KIRKBY – BESS SITE DRAINAGE ADDENDUM

Coopers Lane, Kirkby

KIRK-BML-XX-XX-RP-C-0513

The Addendum to the SuDS Drainage Strategy Report as per Environmental Agency (EA) feedback provides further definition of the drainage catchments within the installation (End 2) and an explanation of the SuDS treatment train components used within the drainage strategy prior to final outfall.

Figure 1: SuDS Drainage Strategy Summar

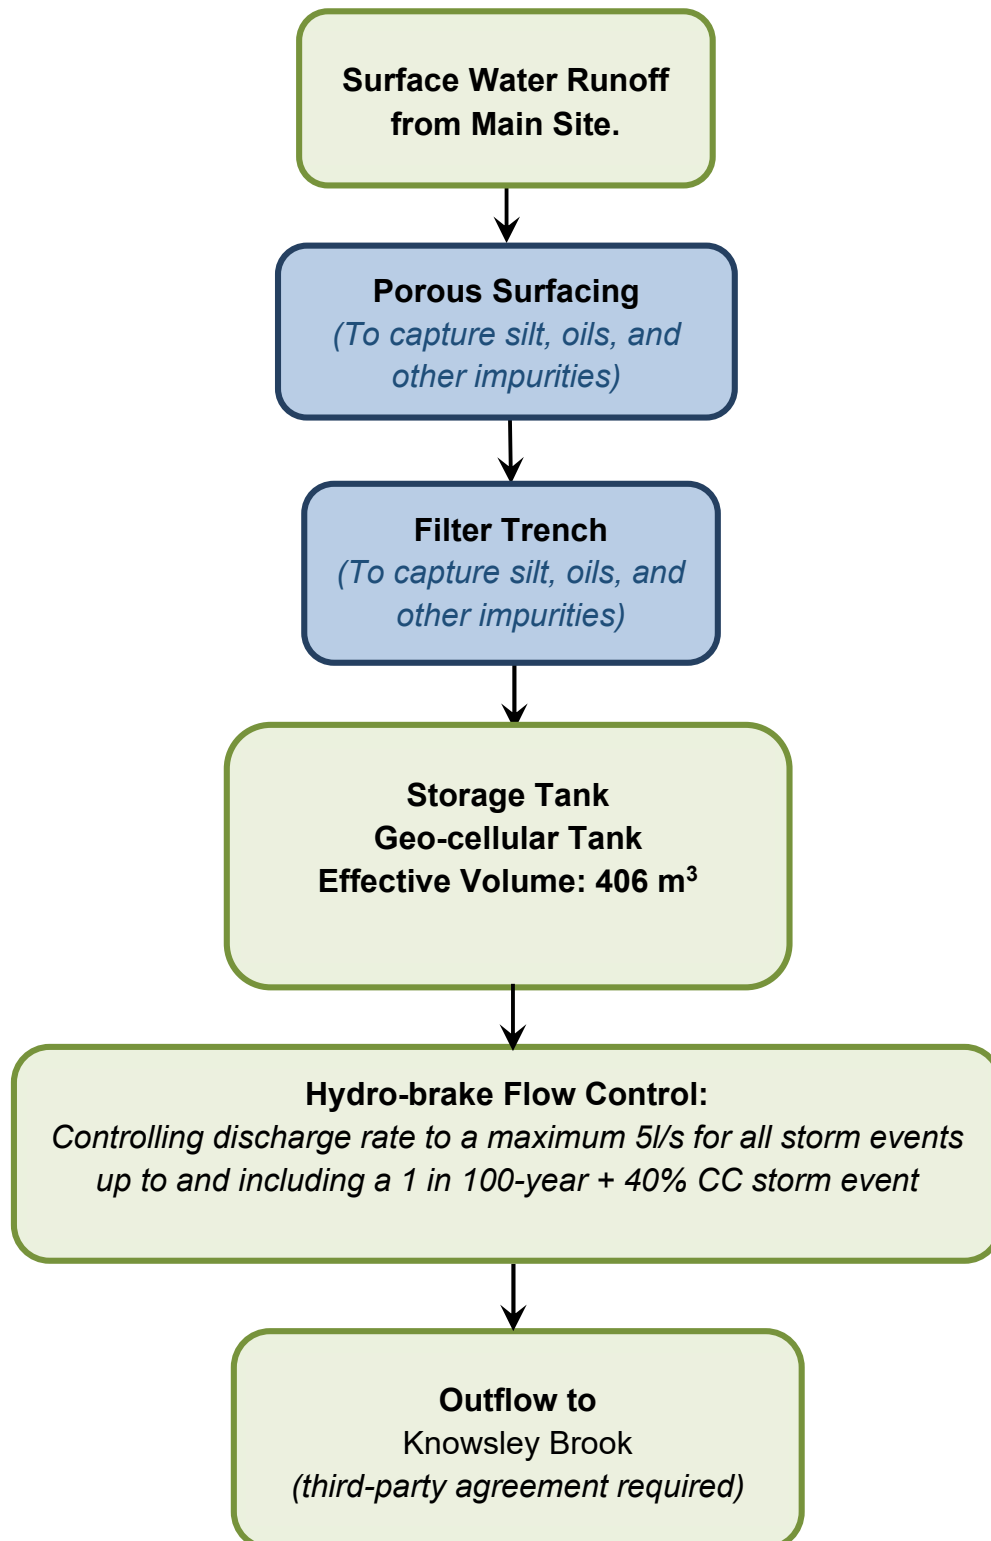
We would require further definition of the drainage catchments within the installation End 2 and then list out the treatment train components before the final outfall. These could then be compared to the [SUDS Manual C753](#) to indicate that sufficient measures are in place. Sustainable Drainage System (SuDS) components and their benefits are not new concepts, however the ability of them to provide containment during a site incident can be unclear.

The drainage strategy of the site follows the SuDS Treatment Train Framework which utilises a series of sequential components with different, overlapping functions to maximise the potential to intercept and treat runoff. Component choice is determined by the characteristics the site and its layout.

The following section demonstrates how these principles have been adopted in the proposed SuDS drainage strategy.

Impermeable Liner Section
Alternative concrete pad option

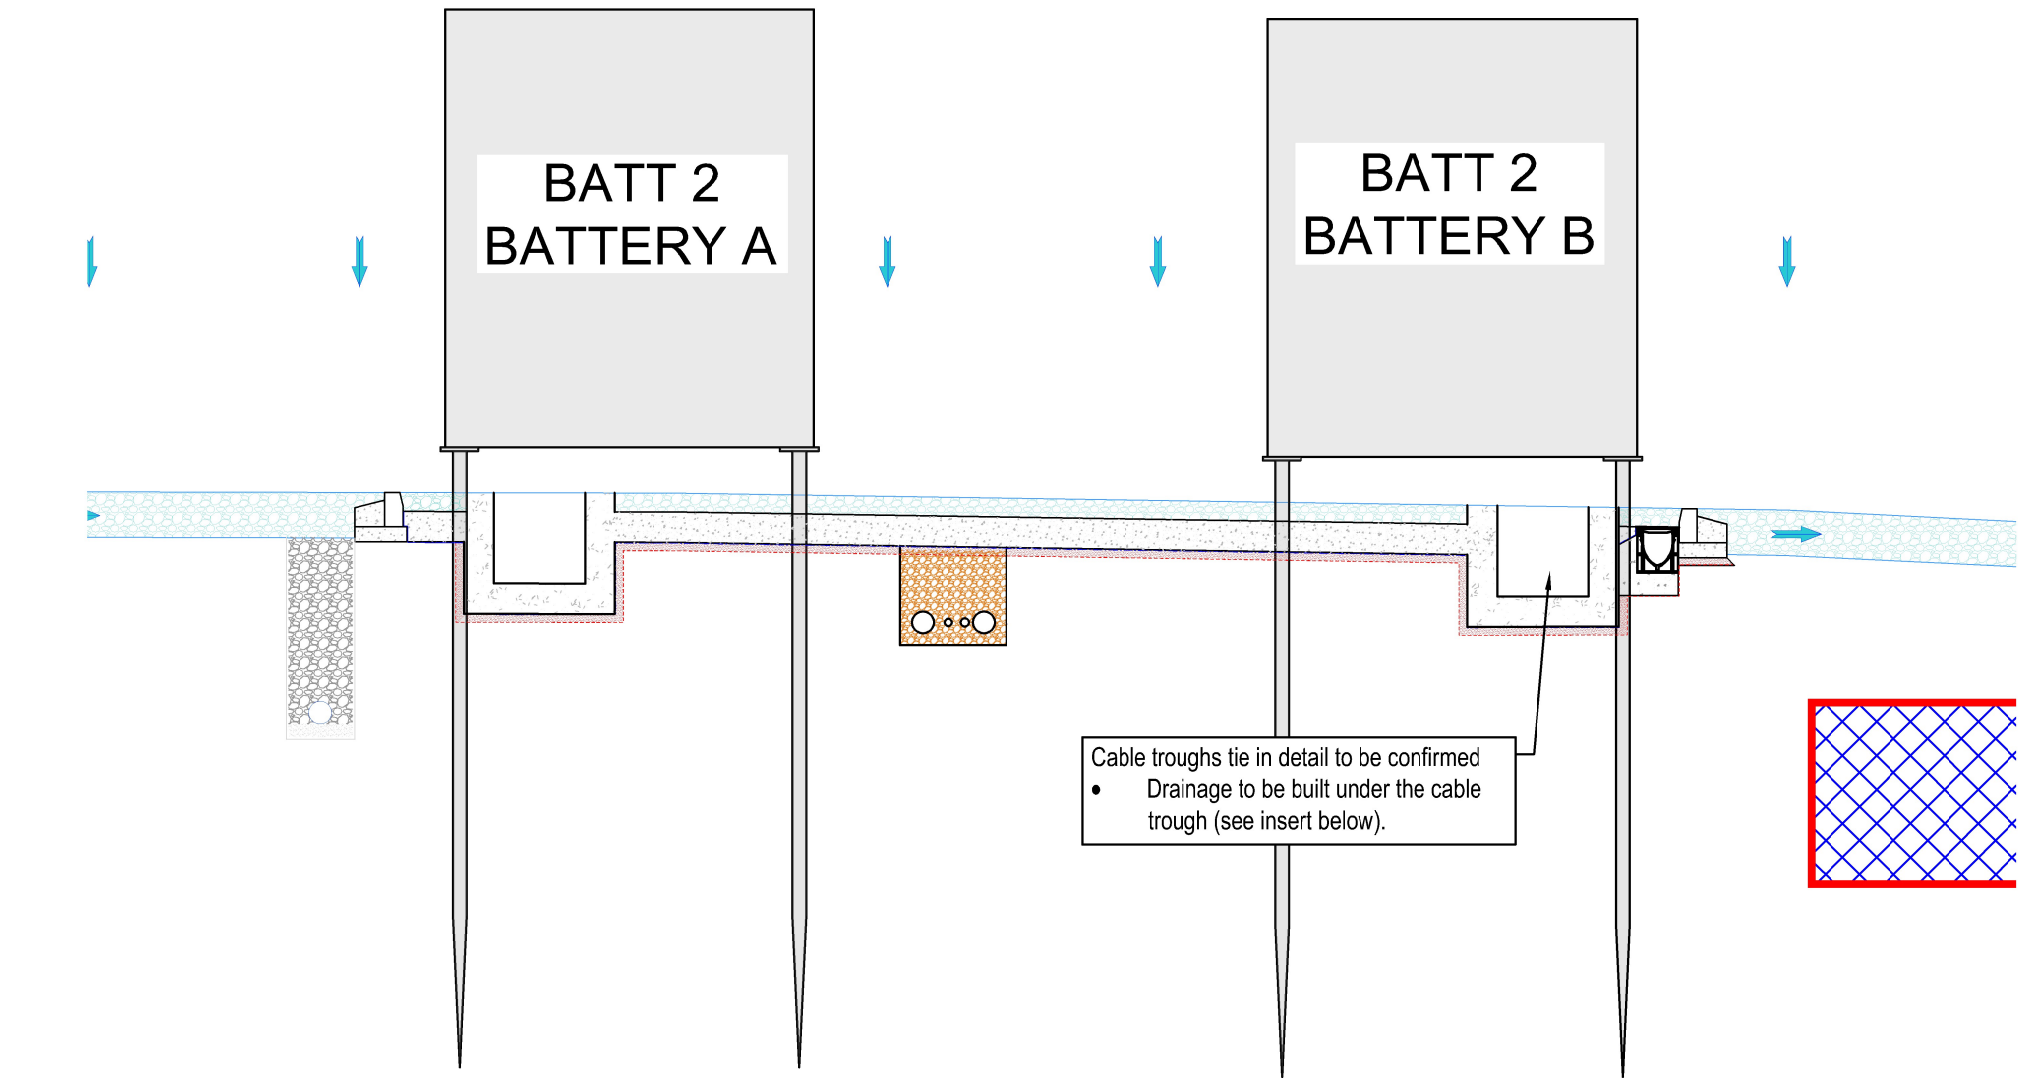
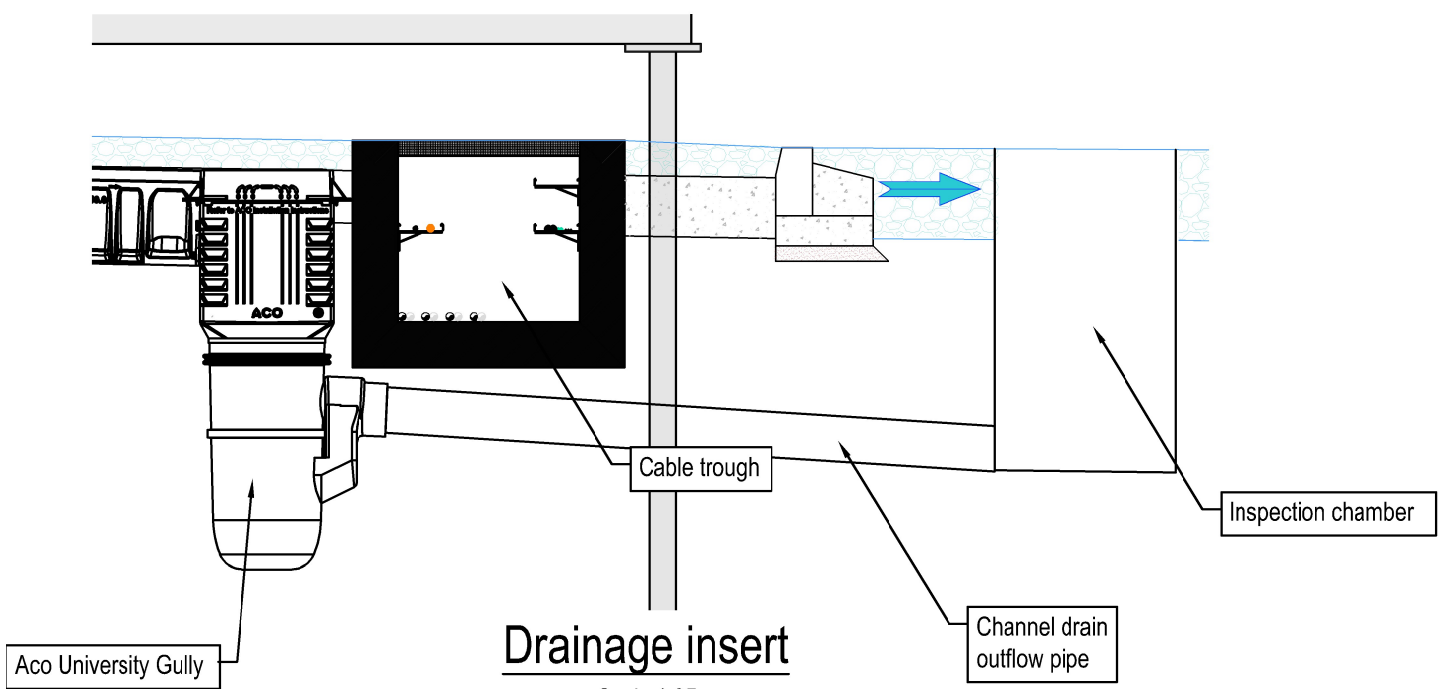
Secondly, it is noted that the site will be underlain by a geotextile which will prevent surface water infiltrating to the ground under normal rainfall events. However, in the event of a fire, there may be runoff created from any firefighting activities which could be chemically aggressive. Therefore information should be provided on the robustness of this geotextile layer during a fire in order to prevent surface water runoff into the ground.

The original proposal included the use of an impermeable membrane beneath the entire site to prevent surface water infiltration under normal rainfall conditions. However, due to the poor ground conditions at the site the use of screw piles as method for the battery unit foundations is required, this would result in several hundred penetrations of the membrane. As a result, this solution is deemed impractical at this site. The proposal is to now contain any fire water runoff from the batteries directly in the position of the battery units using concrete apron bunds.

The area underneath the battery units will be paved with an impermeable reinforced concrete pad of dimension 13.2m x 8.9m surrounded by HB2 kerbs with 125mm upstand (see **Appendix B**). In addition, the concrete slabs will be underlain with a sheet of damp proof membrane (DPM) to prevent any possible infiltration of fire water into the ground underneath in the event of cracking.

The concrete pads are designed to contain contaminated firewater within their bounds. The water is then directed via integrated ACO channel drains located at the perimeter of these concrete pads into the proposed stormwater network via standard solid pipes, which ultimately discharge directly into the attenuation tank.

Drainage Plan Layout

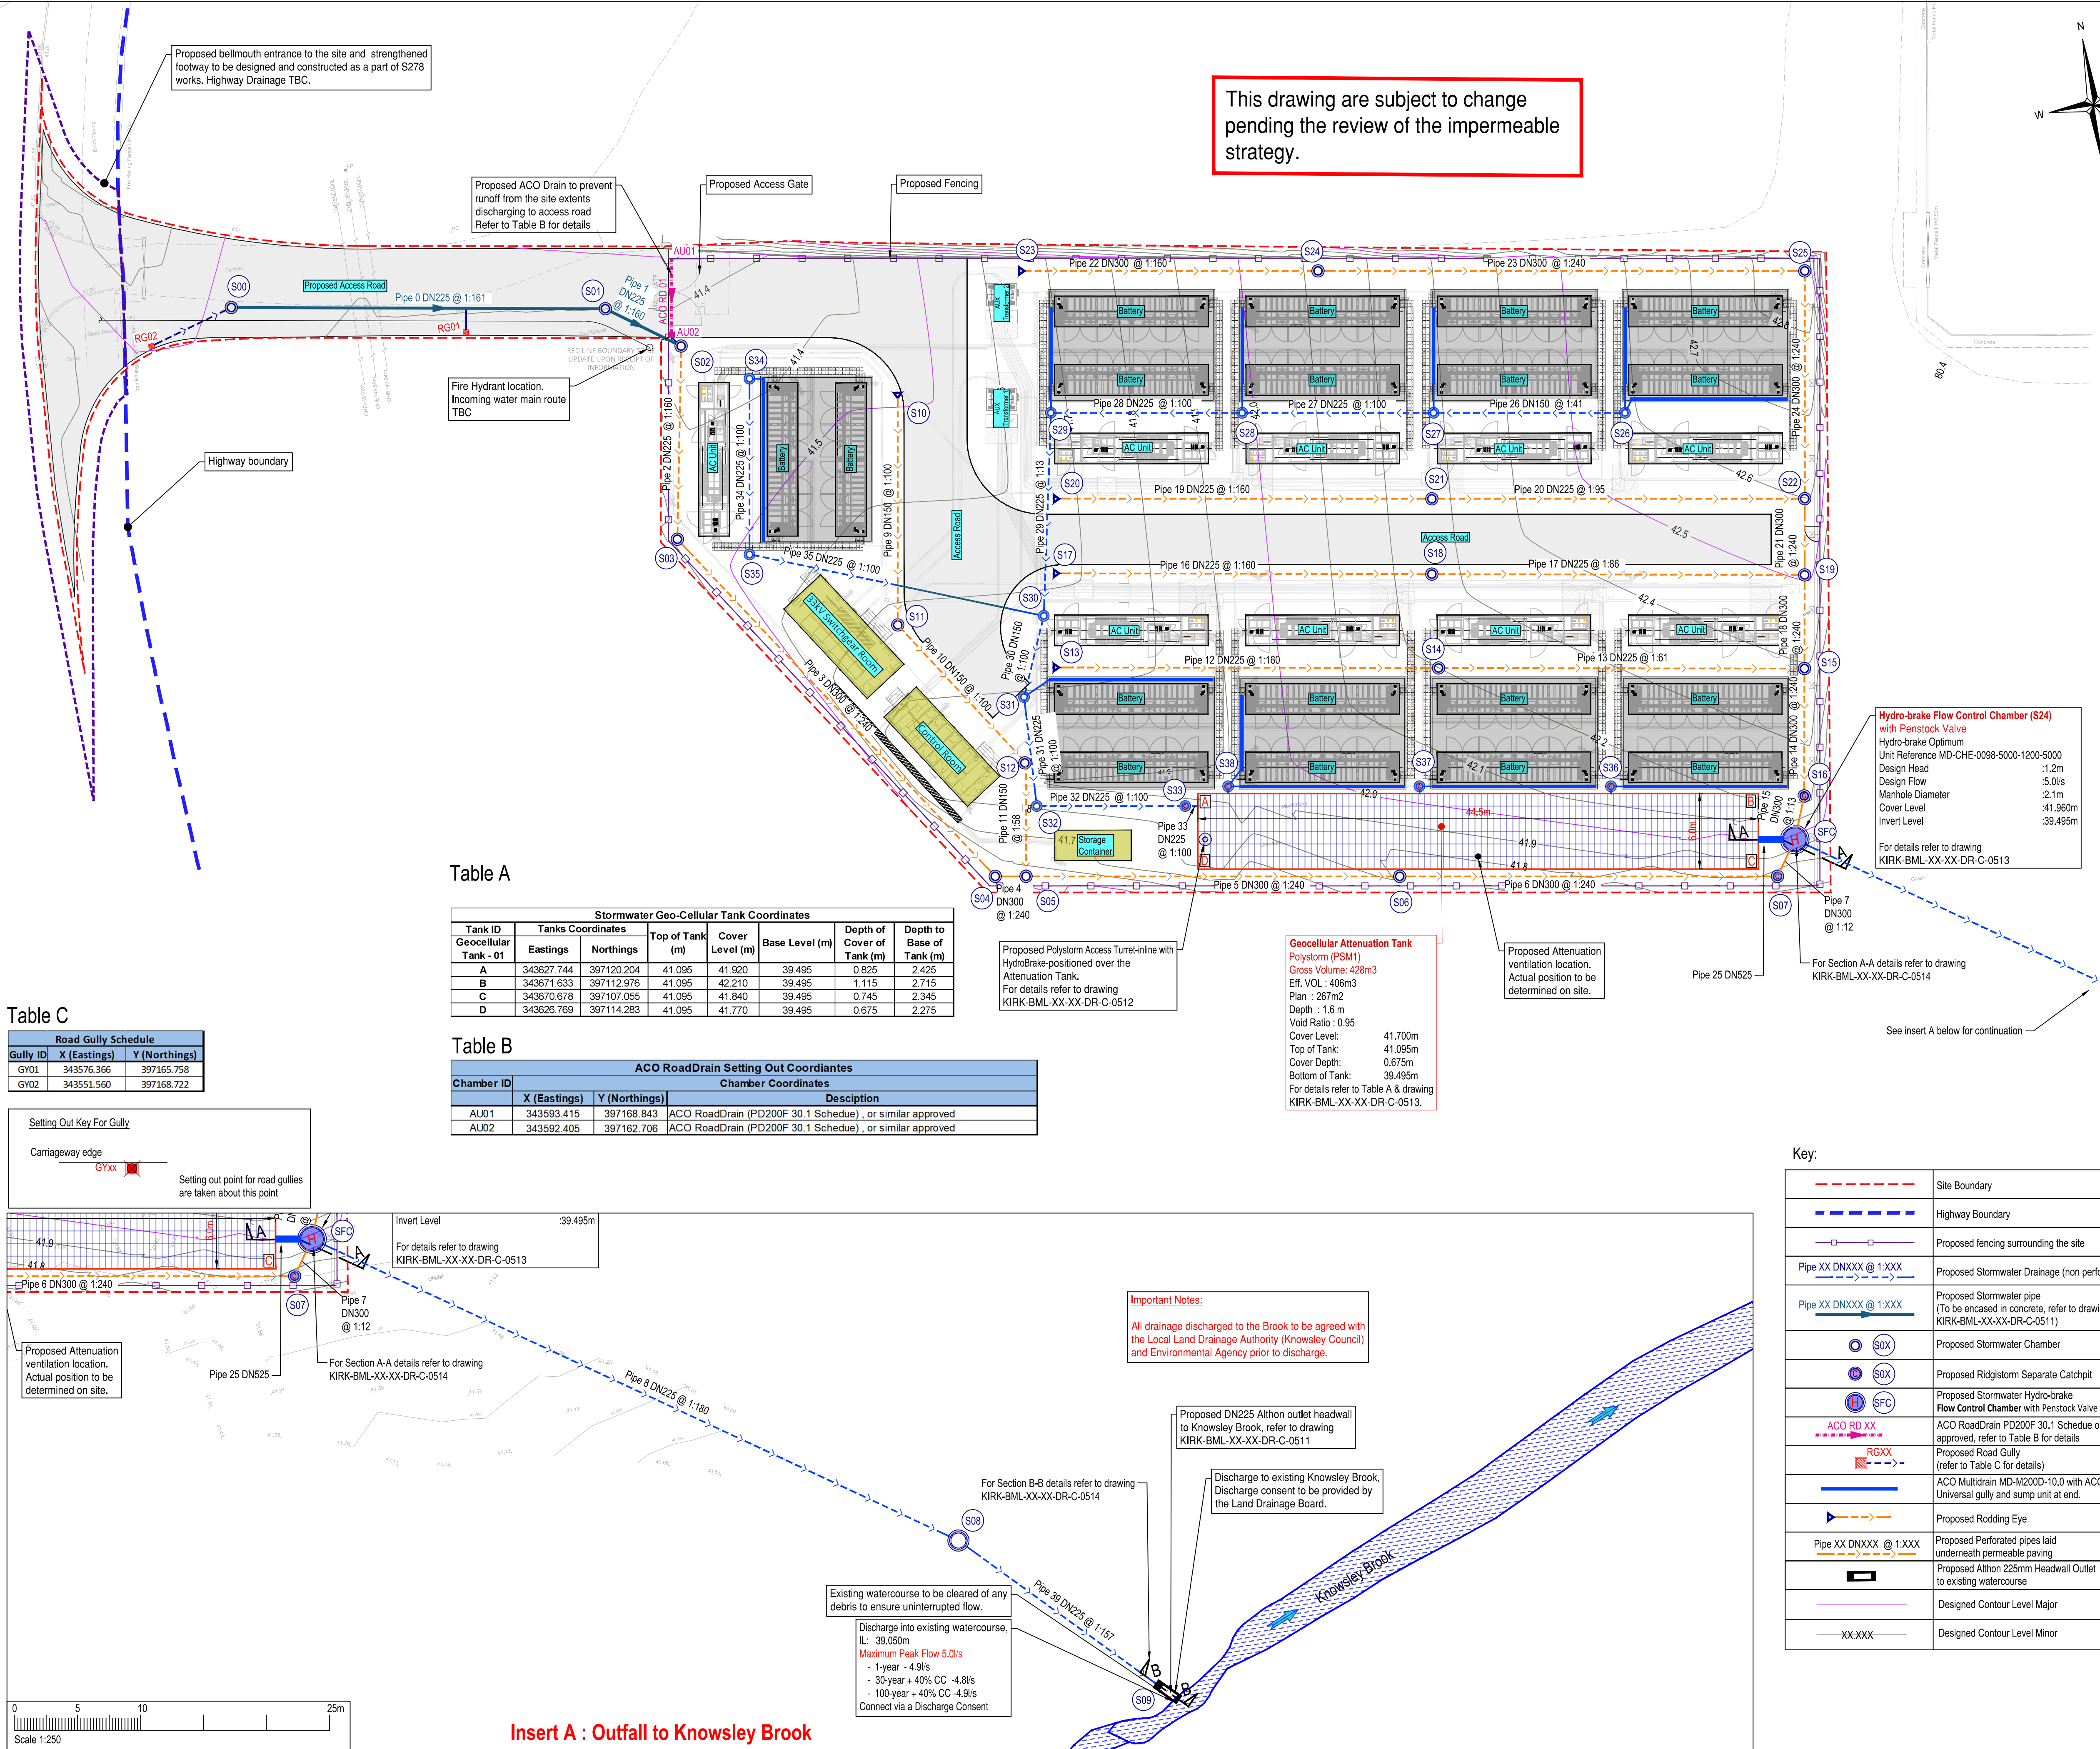
We are still uncertain on the quantity of containment or storage for firewater that has been provided, and further clarification is needed on its management, if this storage is exceeded.

Containment of the firewater on-site is achieved by the operation of penstock valve within the hydro-brake flow control chamber by fire personnel. When this valve is closed the contents of the geocellular attenuation storage are prevented from being discharged to the outfall as they are unable to enter the hydro-brake.

The attenuation tank has been sized for an effective volume of 406 m³. This is sufficient to accommodate runoff from a 1 in 100-year rainfall event, including an allowance of 40% for climate change, in addition to the estimated 180,000 litres of contaminated firewater runoff. This value of 180m³ is taken from the draft guidance provided by the National Fire Chiefs Council (NFCC) and has been used for similar BESS sites. The contaminated water will be temporarily stored in the tank until it can be safely pumped out and treated for appropriate

disposal. However, since the stormwater from the filter trenches discharges directly into the hydro-brake chamber, it will still be able to flow off-site, preventing flooding within the site.
